## DRAFT FOR DISCUSSION

October 22, 2018

**RE: Greenwood Aggregates Proposed Violet Hill Pit Peer Review Visual Assessment  
OUR FILE 1767'B'**

1 PROPOSED BERM AND BUFFER SCREENING - DETAIL AREA A  
L1 1:400

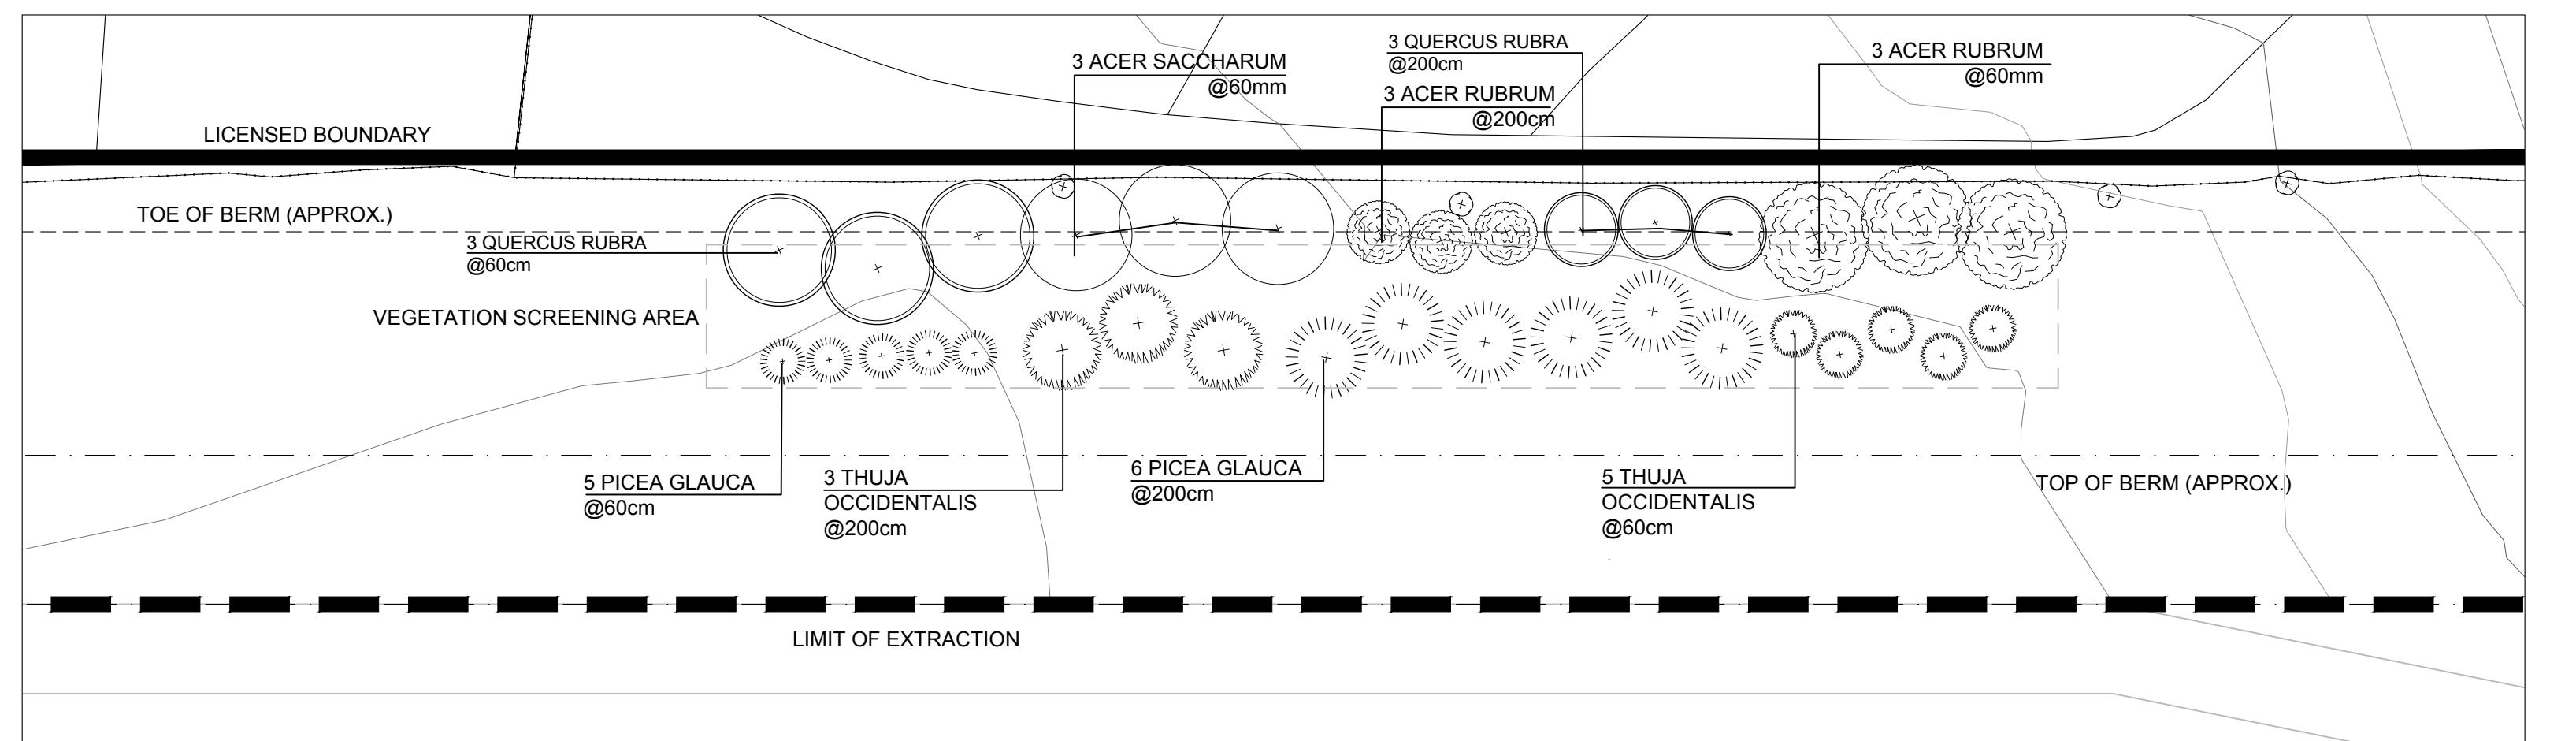
#### **Item 2- Visual Screening for R3**

The conclusion of the original Visual Assessment (VA) report with respect to R3 was that views are "slight" at the 5 metre berm height and blocked once the berm is raised to 10 metres. To be more specific, this reflects the sight line assessment which suggested a small portion of the upper pit face might be visible at a distance of approximately 600 metres with the lower berm elevation. The pit floor operations or products stock piles would not be visible. The possible exposure of the upper pit face would be short-term given the location of this pit face and the requirement for progressive rehabilitation. However, the operational phasing dictates that the berm must be raised to 10 metres prior to the extraction of Areas B and C that results in the creation of the partially exposed pit face. Accordingly, the higher berms, that effectively block the view, will be in place before the potentially exposed pit face is created.

Accordingly, we do not think additional mitigation is required for R3. Regardless, Greenwood is proposing vegetation plantings along the fence line in front of R3, R4 and R5 that will further mitigate any potential views of the pit face.

R3- R5- The original VA found that there was potential/slight views when the proposed berm is at 5 metres but the views are blocked at the 10 metre high berm. The recommendation is for a tree screen on the property line to provide additional mitigation.

# Page 2 of 3 VISUAL ASSESSMENT

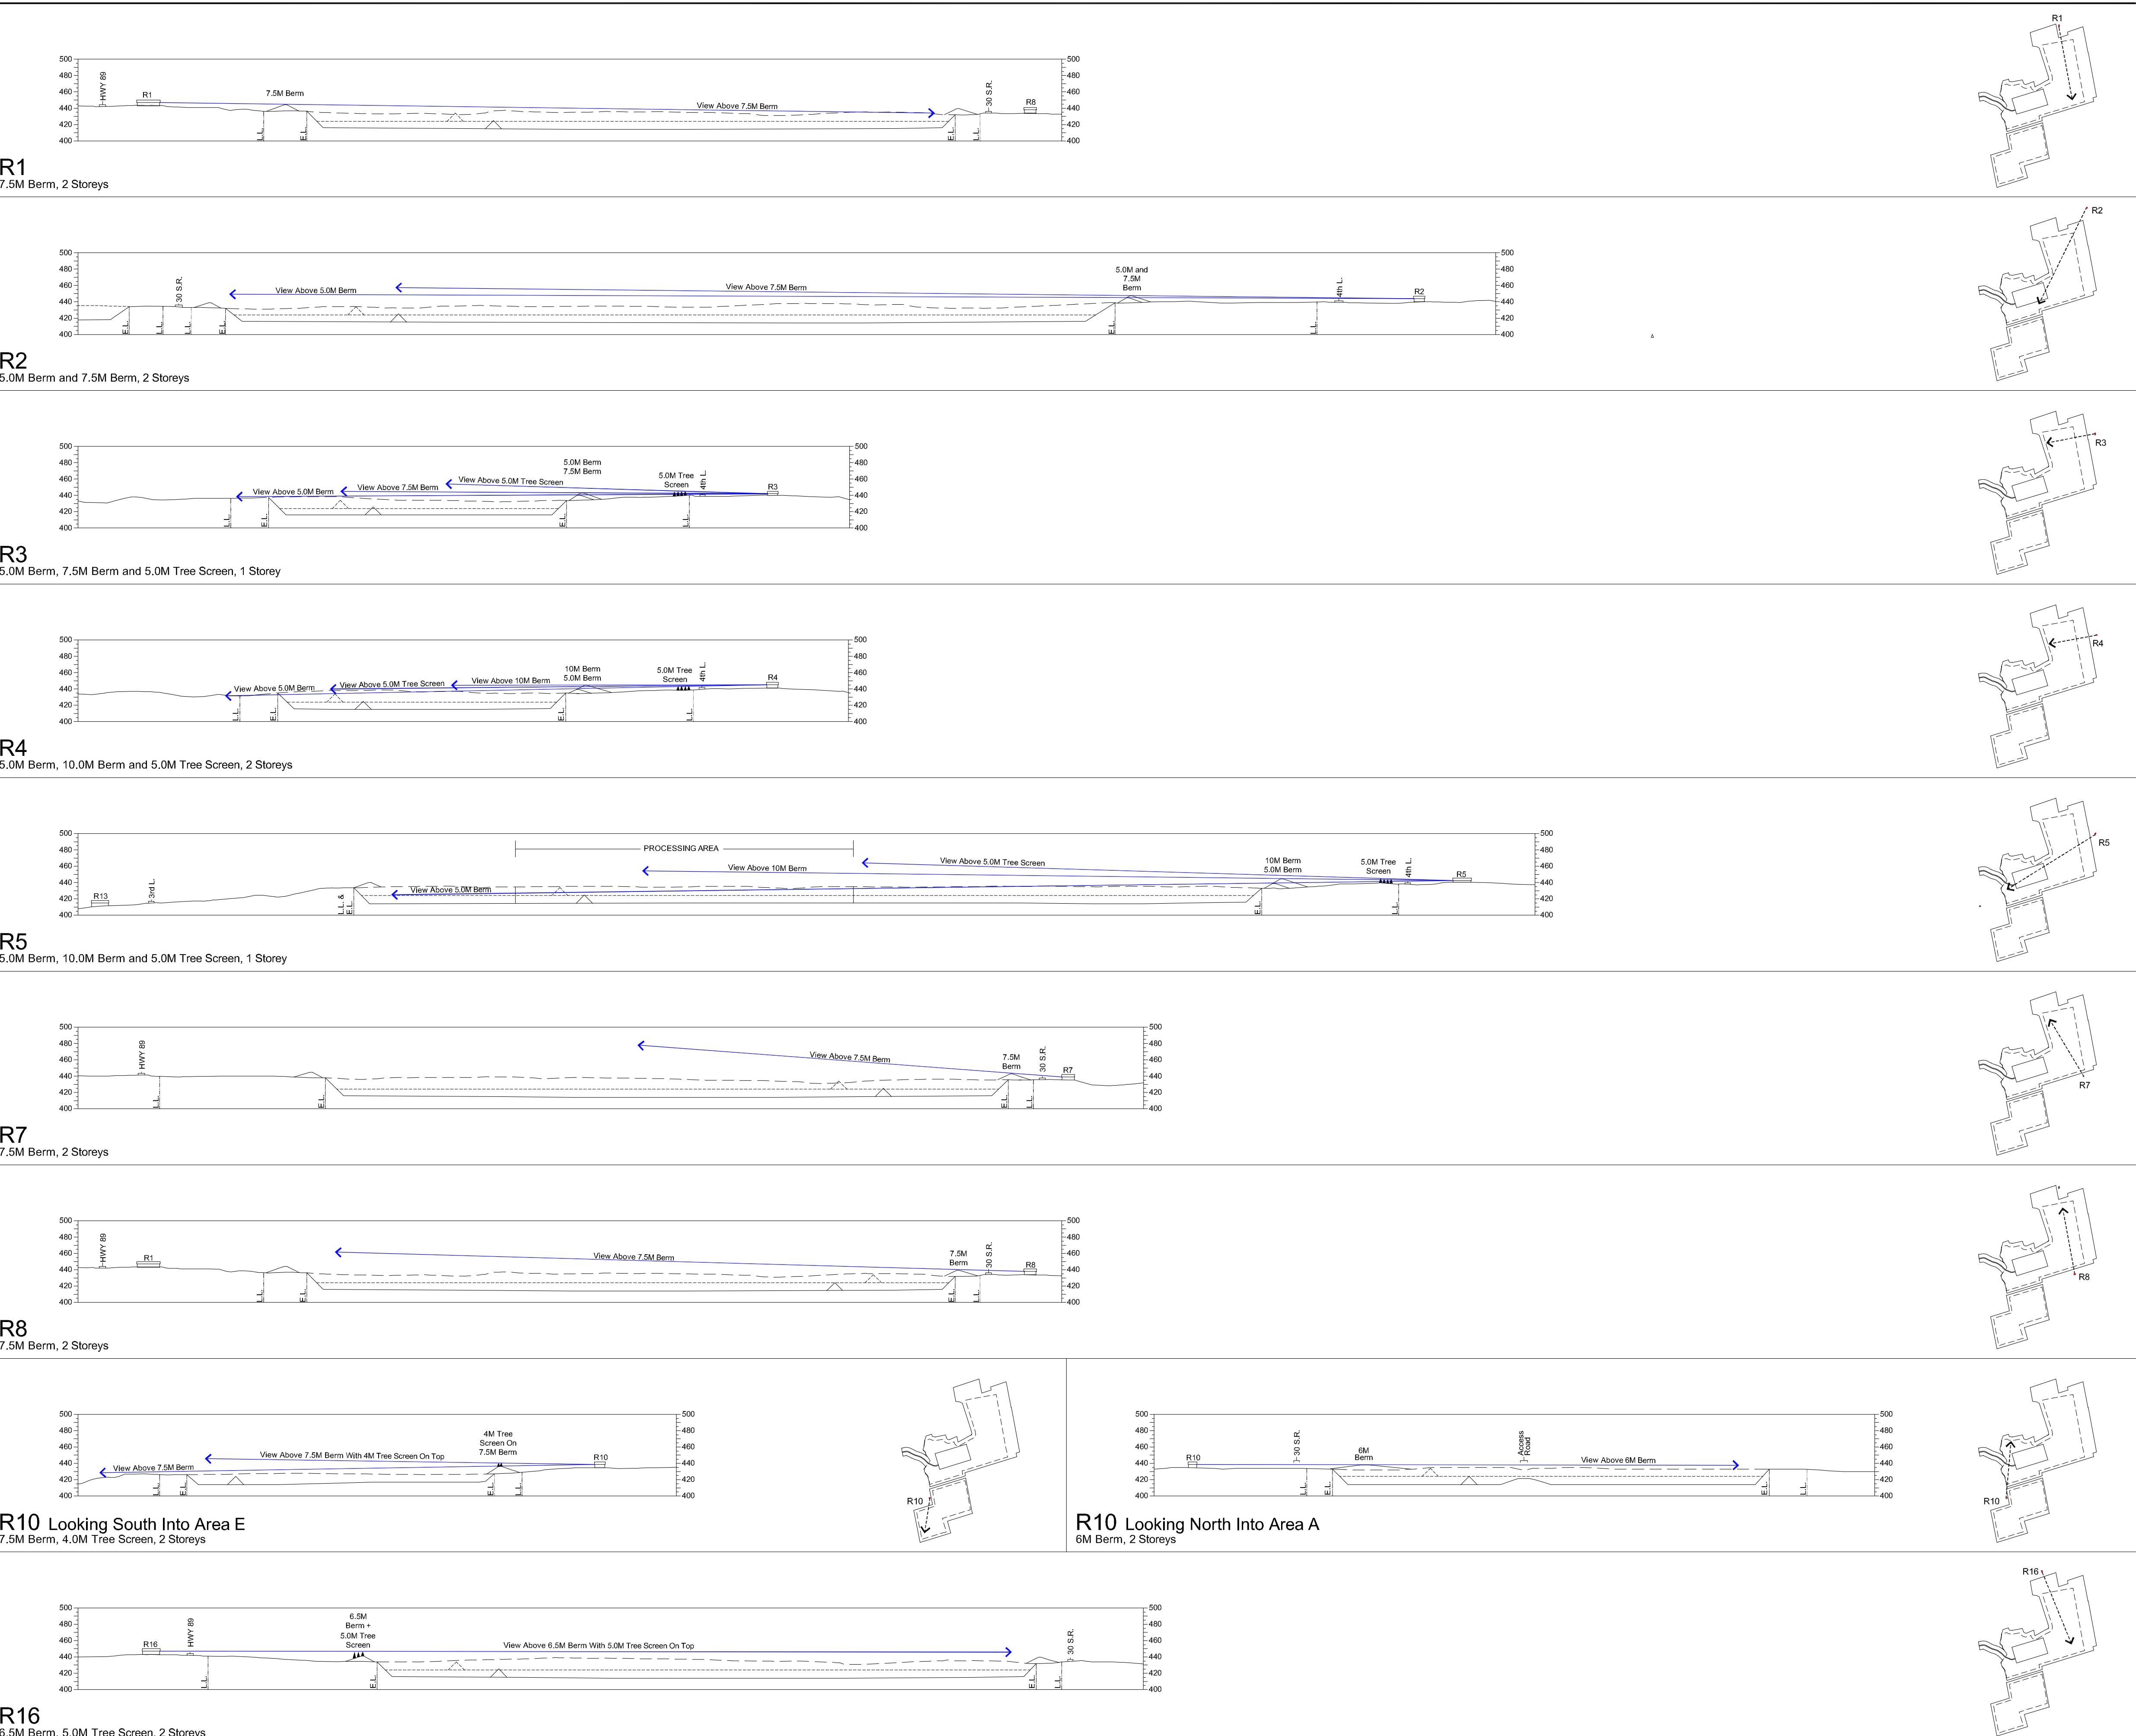
We can also confirm that views from upper levels of existing homes have been considered as noted on the Visual Assessment Table. Note that this has been updated since the original report was completed (see enclosures).

### Page 3 of 3 **SUPPLEMENTAL VISUAL SECTIONS**

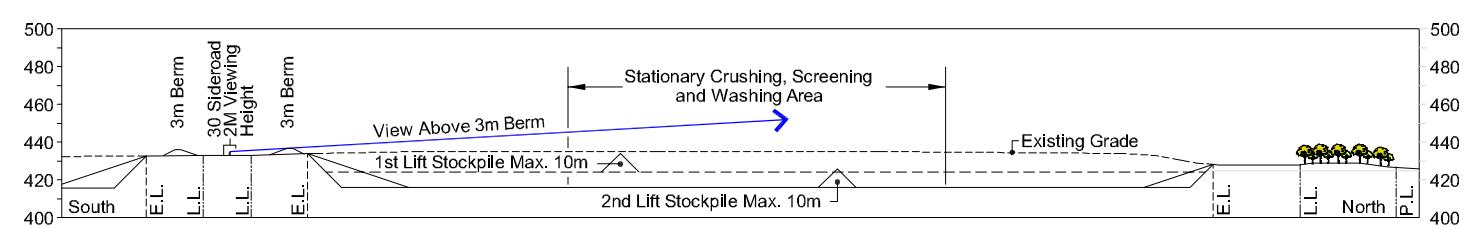
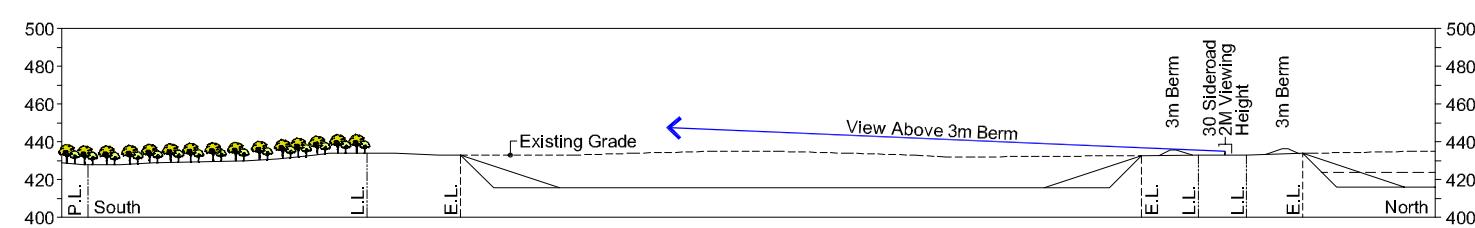
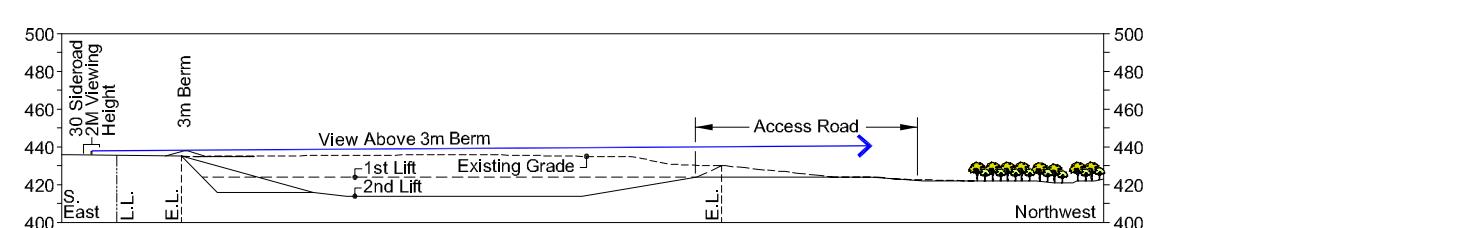
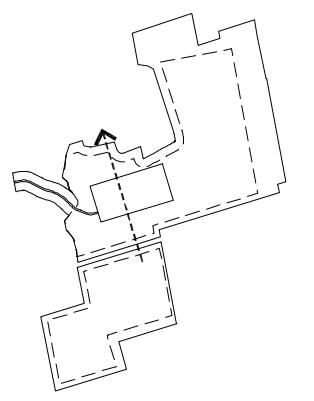
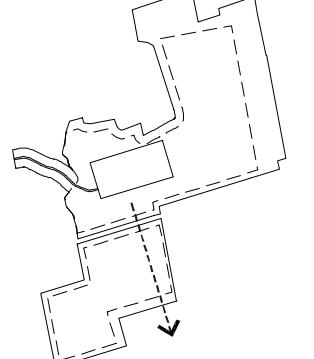
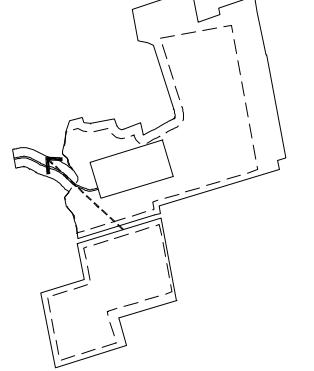
### **Item 7- 30 Side Road Entrances**

The entrance design has been revised to include additional offset/overlap of the berm to better mitigate the views into the pit. Please see attached plan. Additional sections have been prepared to demonstrate the effectiveness of the 3 metre high berms.

As noted above, the overlap has been increased to provide effect screening into the pit operations.
